Service Action: Replace Wheel Bolt Wrench

F56 (Cooper)

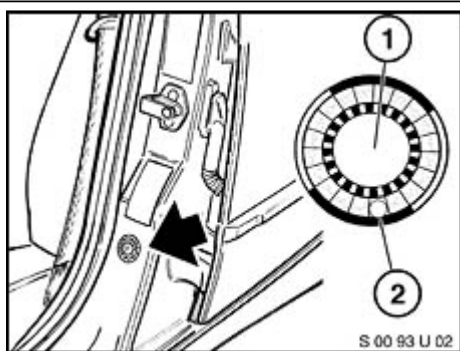
The vehicle tool kit can be found under the floor mat in the main luggage compartment. In the vehicle tool kit, the wheel bolt wrench (4) must be replaced by a new

version with an internal thread size of M10.

Replace the wheel bolt wrench in the vehicle tool kit.
